<b>PROJECT/SITE OWNER:</b>  Mark and Anne Berkoff <b>PROJECT ADDRESS:</b> 9240 N Tennyson Dr.	<b>PROJECT SUMMARY:</b>  Addition to the house 545 square feet Fence 6 foot tall black aluminum 36 feet open design
---	--

I have reviewed the proposed single-story addition and fencing for compliance with the Village's ordinances and have determined the following for consideration.

**VILLAGE CODE REVIEW**

## Plat of Survey

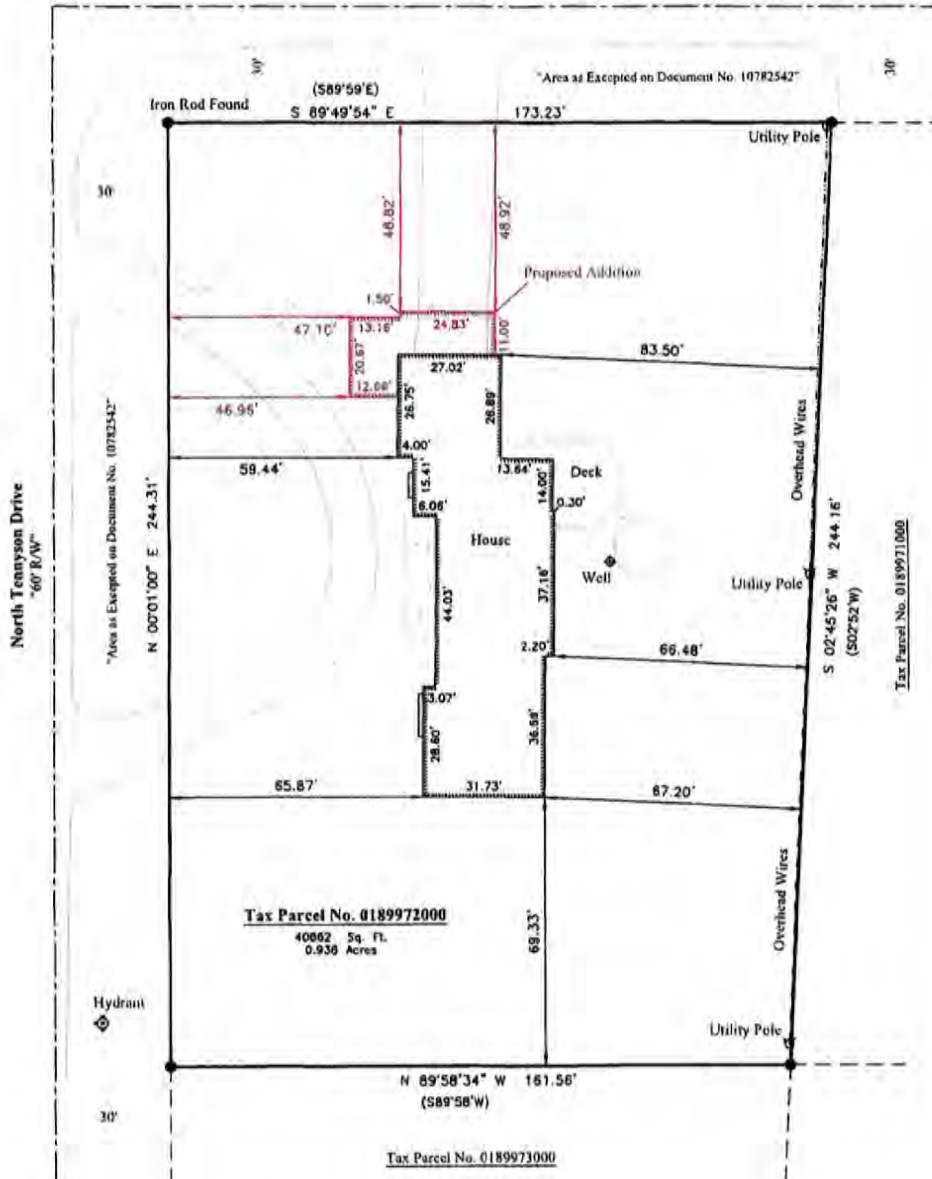
1. Meets current setbacks
2. Meets the required height restrictions
3. A current survey was submitted.
4. The applicant stated that they are matching the existing house with materials.
5. The board always considers the aesthetics of the project.
6. The proposed fence meets the Villages fencing ordinance.
7. This review is only for ARC and not for a building permit.

WALL SECTION THRU. WINDOW WELL

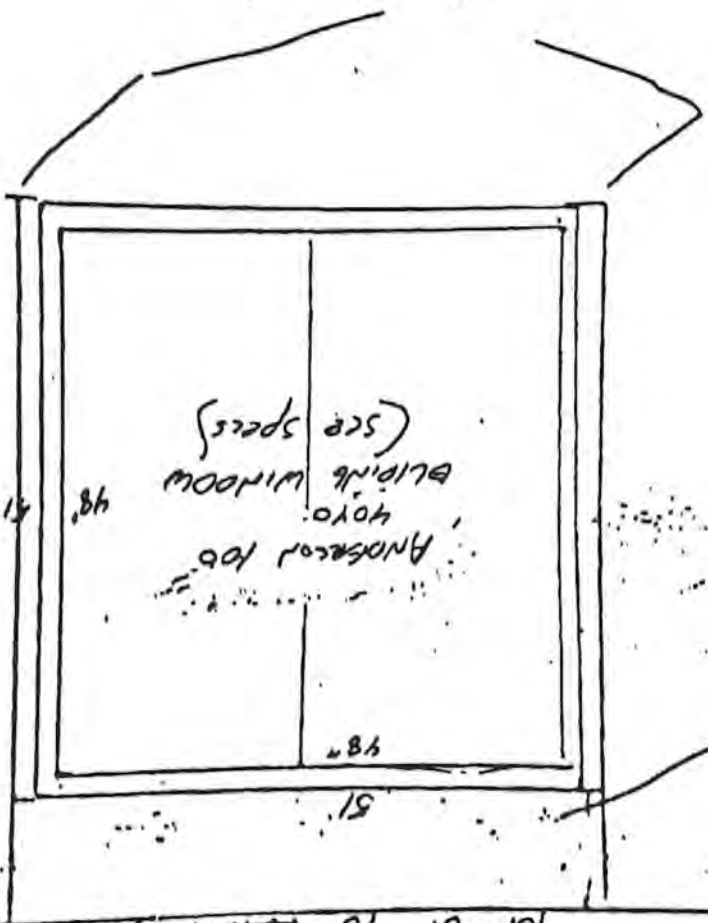
1. The owner states that the egress window will be installed on the front of the house
2. There are no other issues with this submittal.

# PLAT OF SURVEY

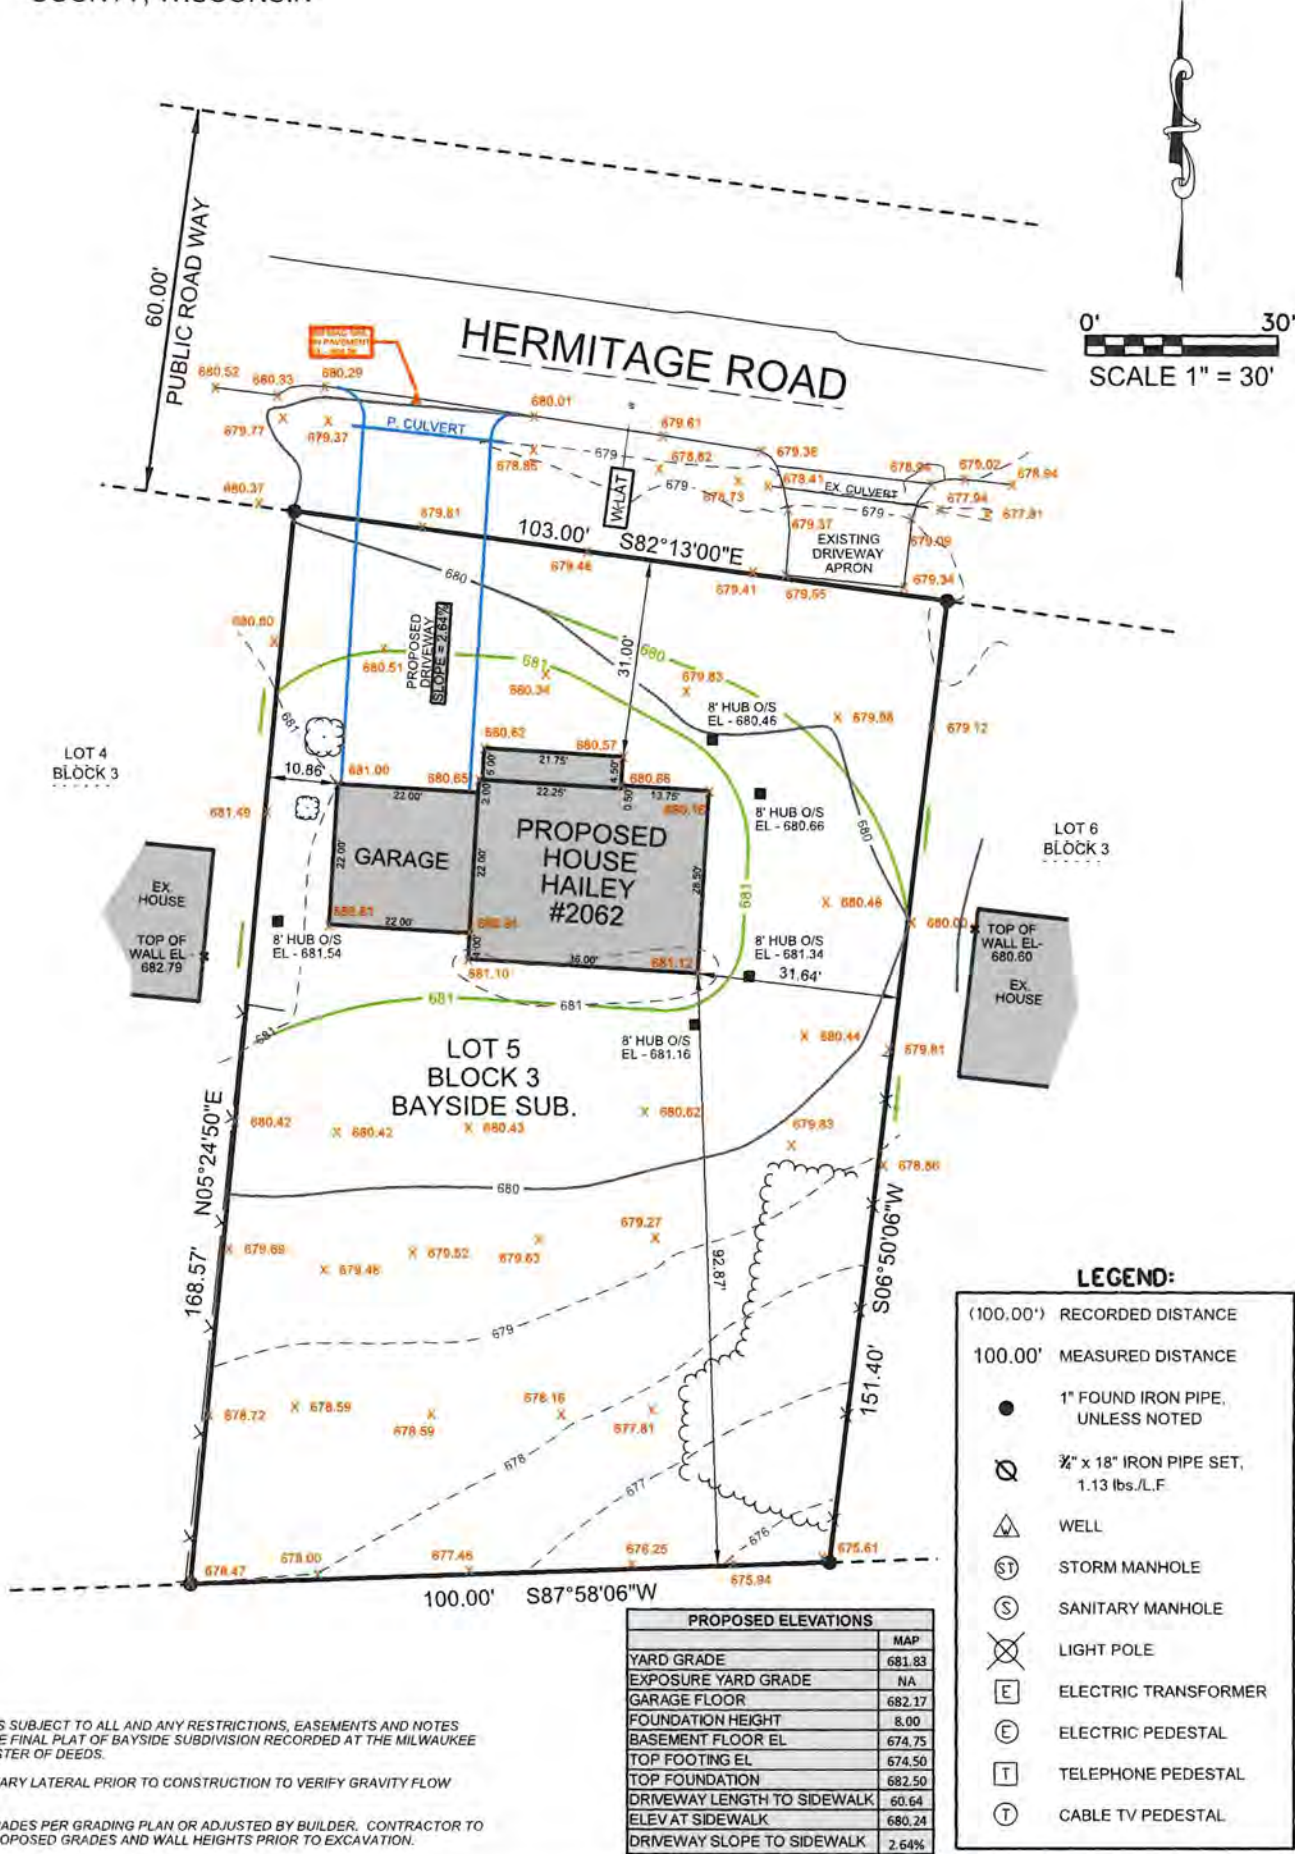
1. The proposed submittal meets the prescribed ordinances.
2. The board always considers the aesthetics of the project.
3. **This review is only the ARC and not a building permit.**
4. **Grading plan must be reviewed by the Villages Engineer**
